PIVOT ARCHITECTURE

ADDENDUM # 5

Project: **Klamath Community College Childcare Learning Center (2331.00)**

Date: September 4, 2025

A112

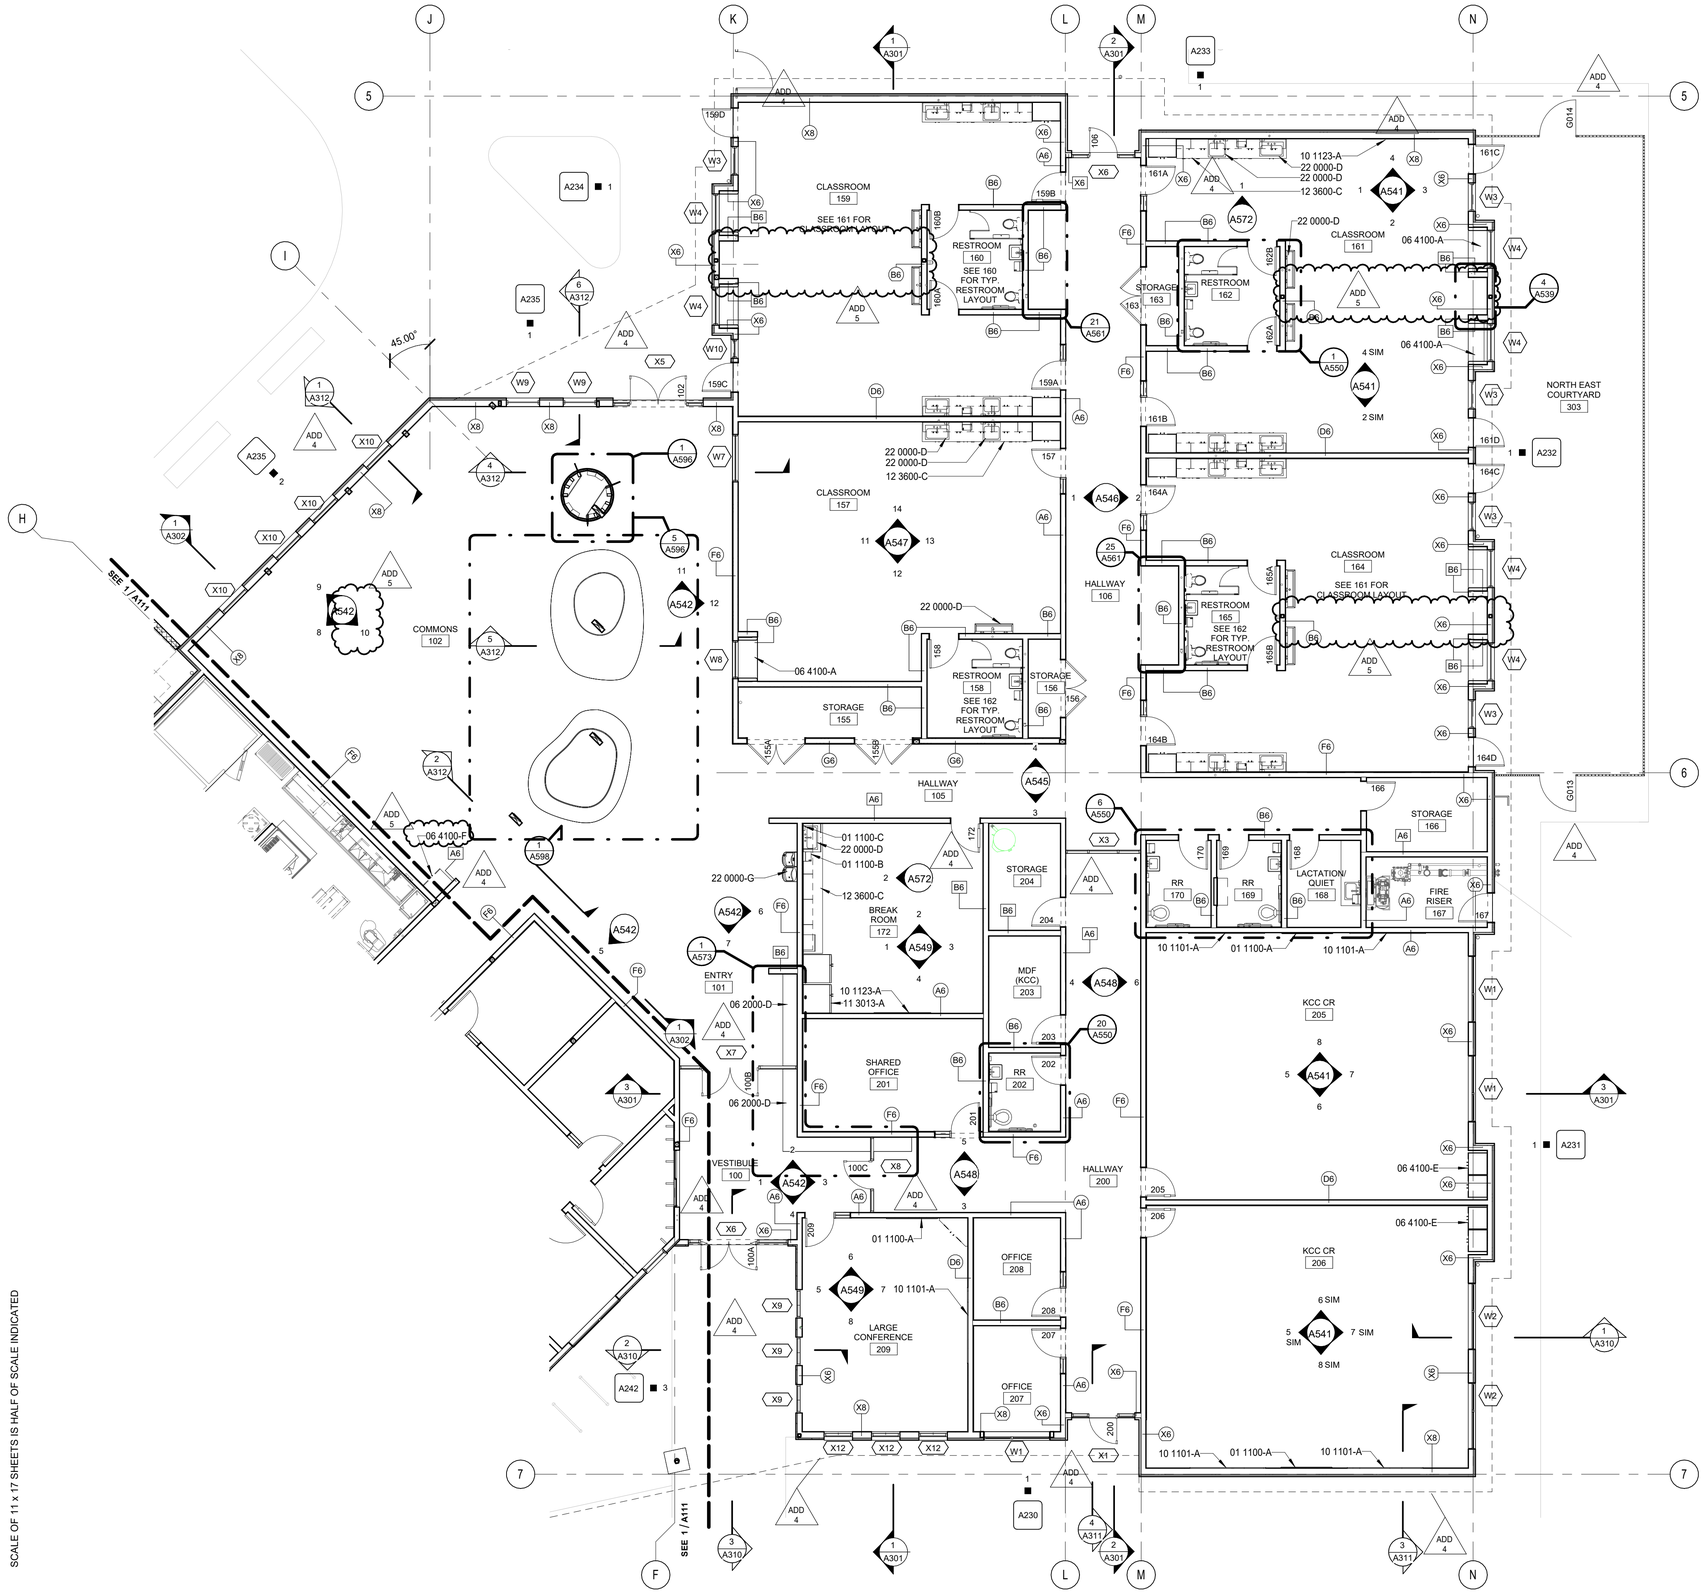
3.13. A112 FLOOR PLAN SECTOR B
- 3.13.1. REMOVED folding panel partitions from all classrooms
- 3.13.2. ADDED OFCI to tackable wall system keynote
- 3.13.3. ADDED keynote to cabinet in Commons

1 REFLECTED CEILING PLAN - SECTOR A

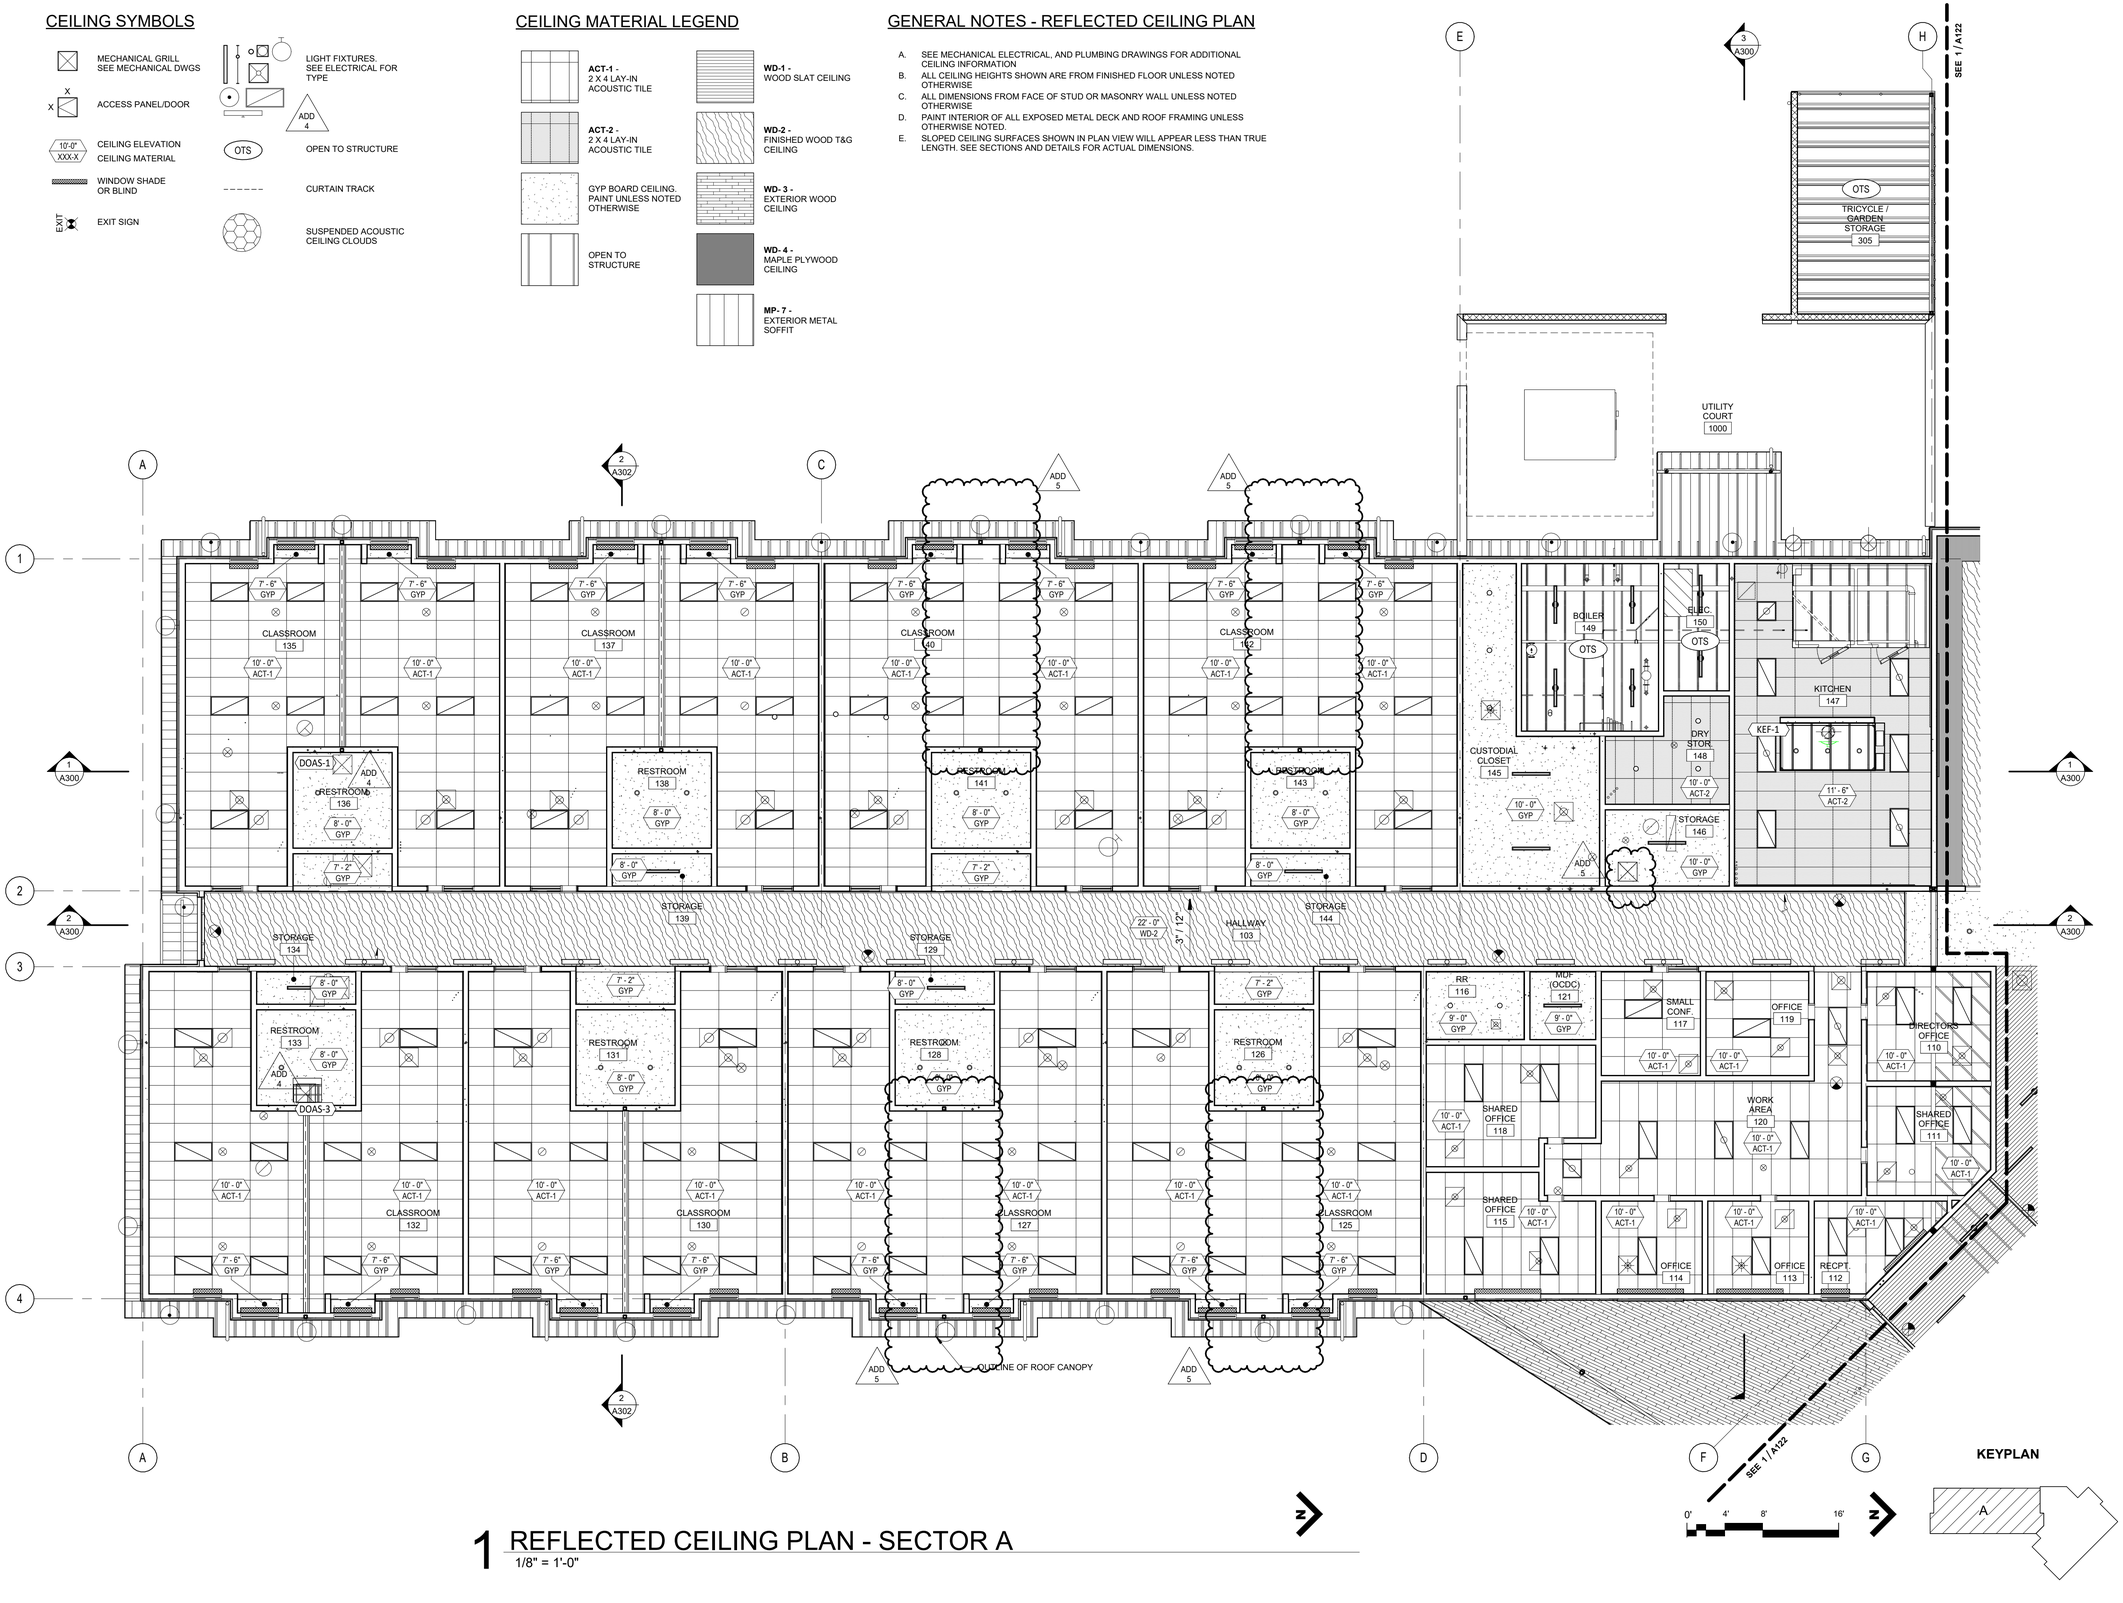
3.15. A121 REFLECTED CEILING PLAN – SECTOR A
- 3.15.1. REMOVED Operable partitions from all classrooms except for classrooms 135, 137, 132, 130

1 REFLECTED CEILING PLAN - SECTOR B

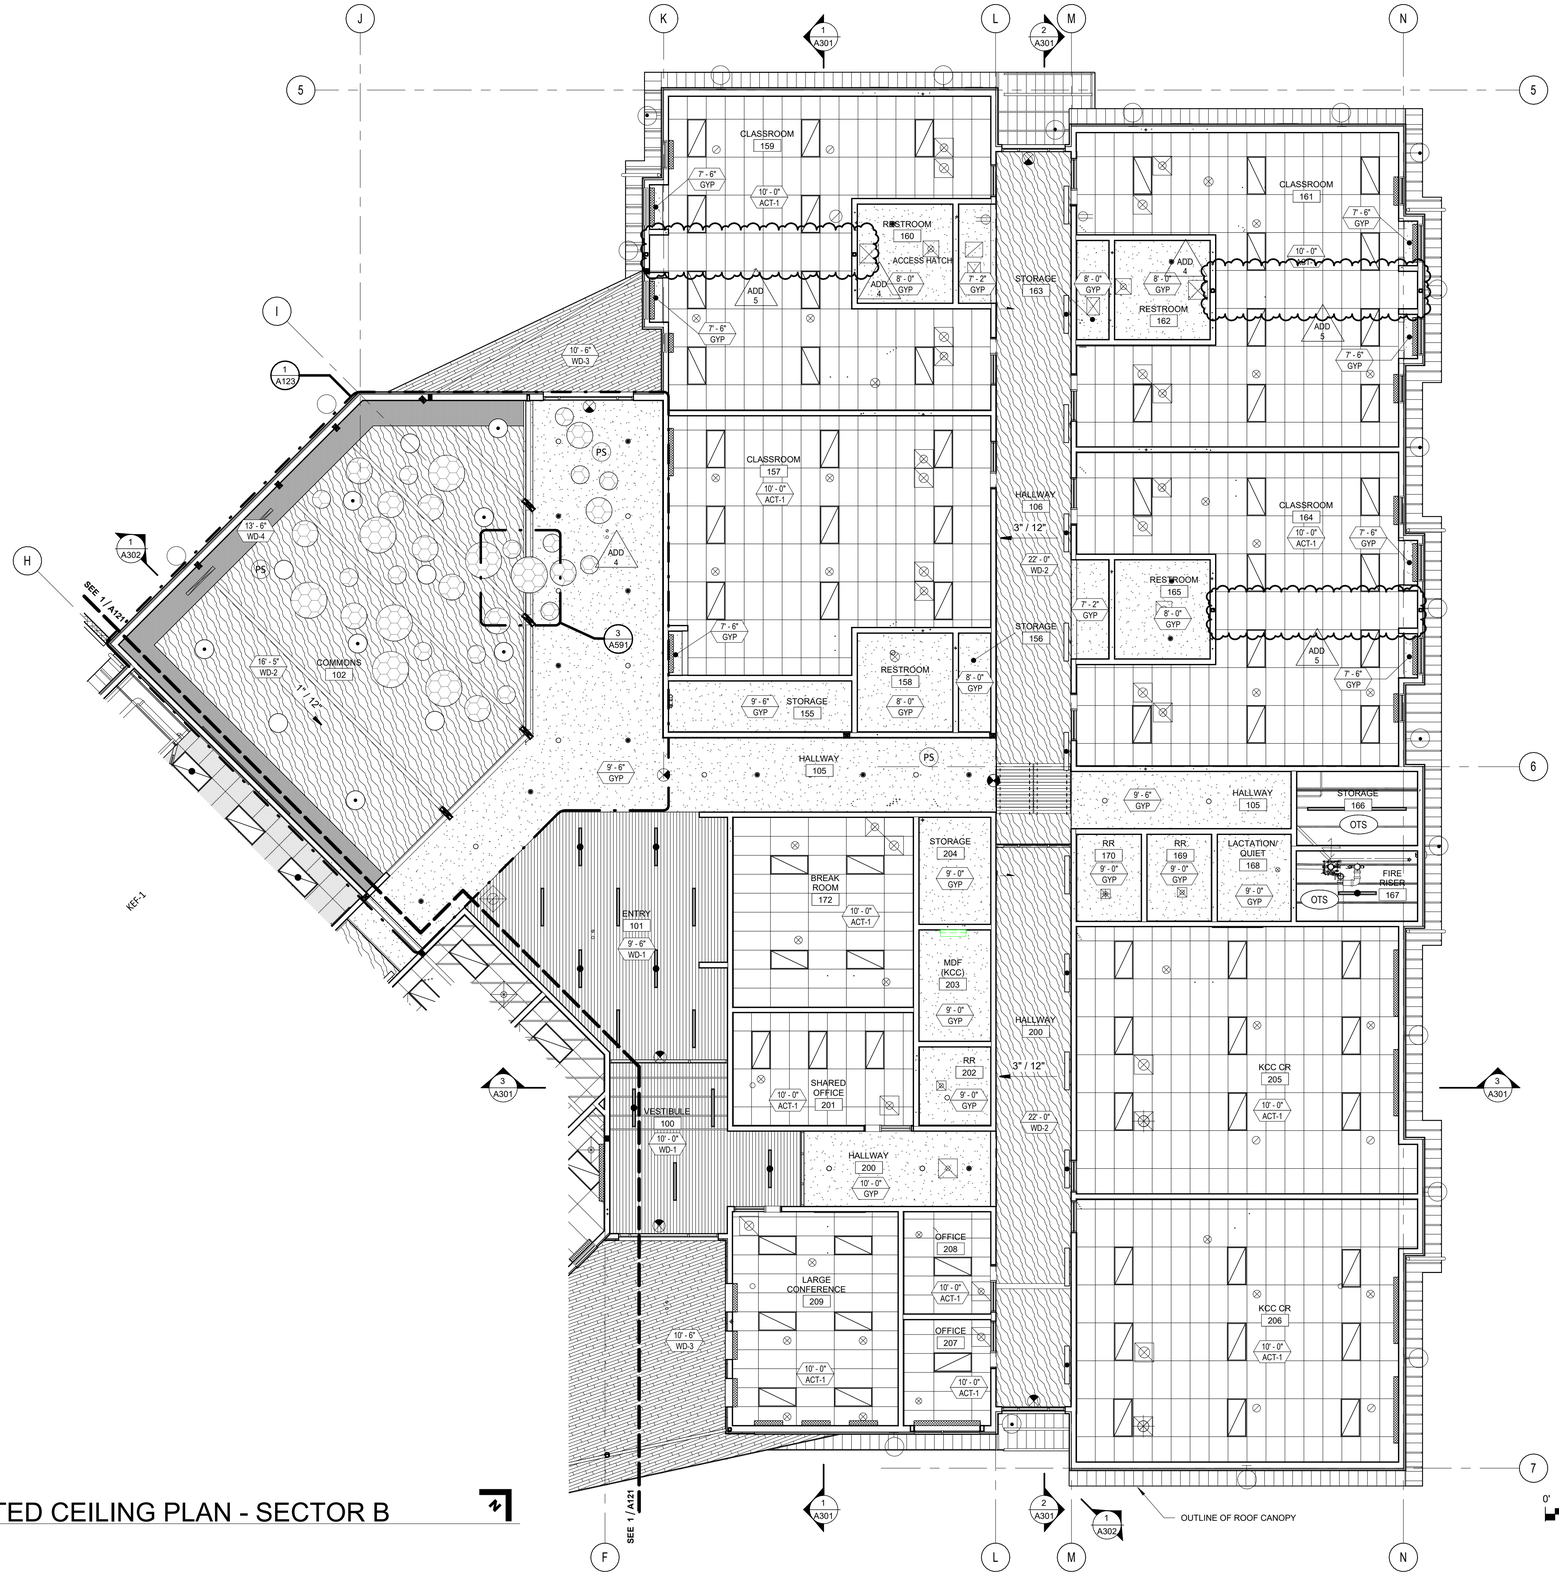
3.16. A122 REFLECTED CEILING PLAN – SECTOR B
- 3.16.1. REMOVED Operable partitions from all classrooms

1 ROOF PLAN - PVC
1/8" = 1'-0"

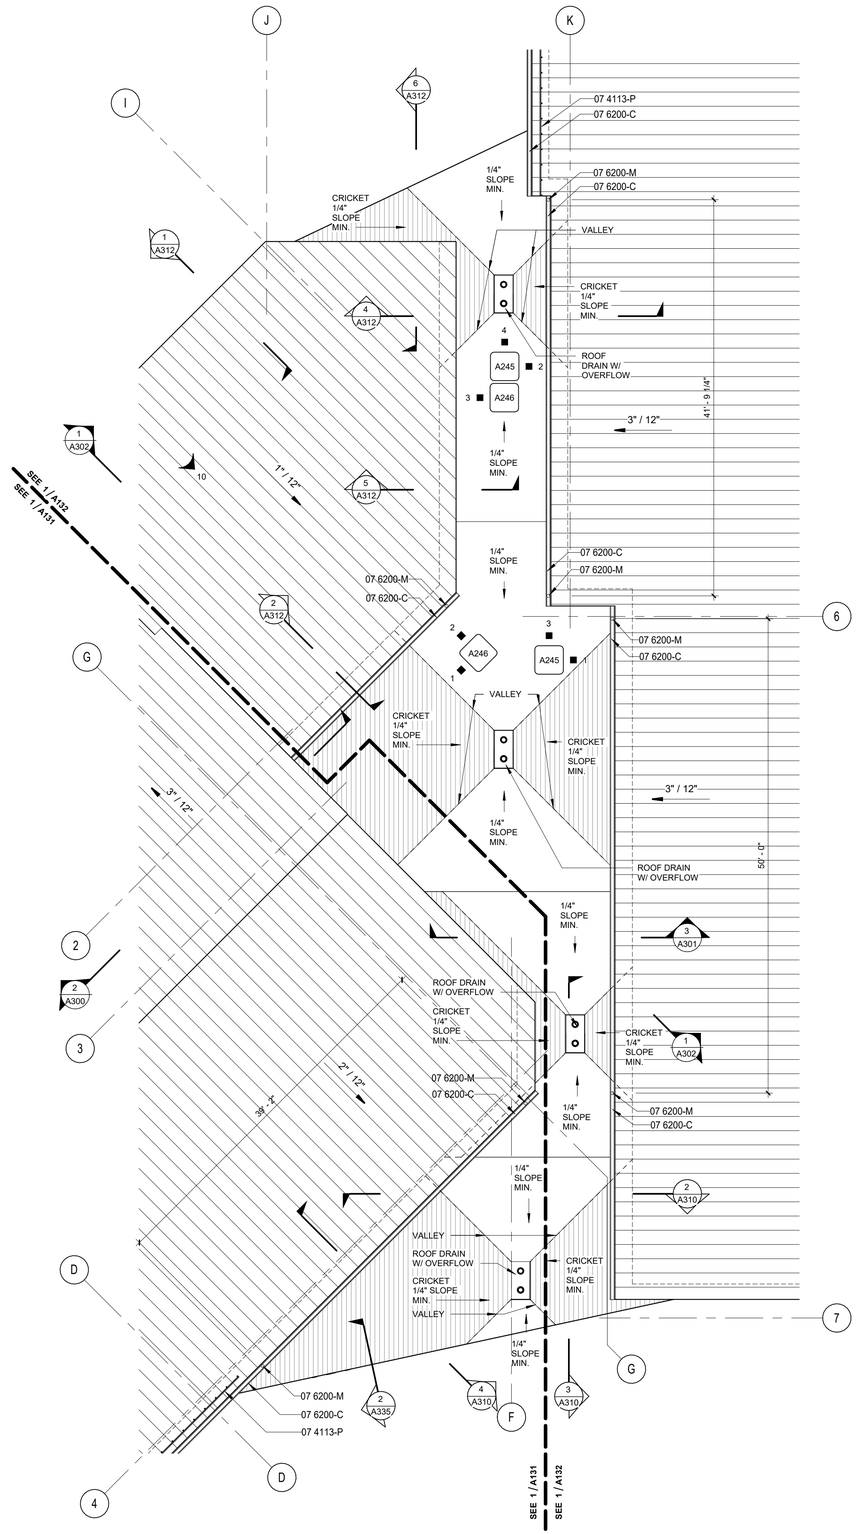
3.17. A133 ROOF PLAN - PVC
- 3.17.1. NEW SHEET ADDED, PVC roof tapered insulation and drainage plan
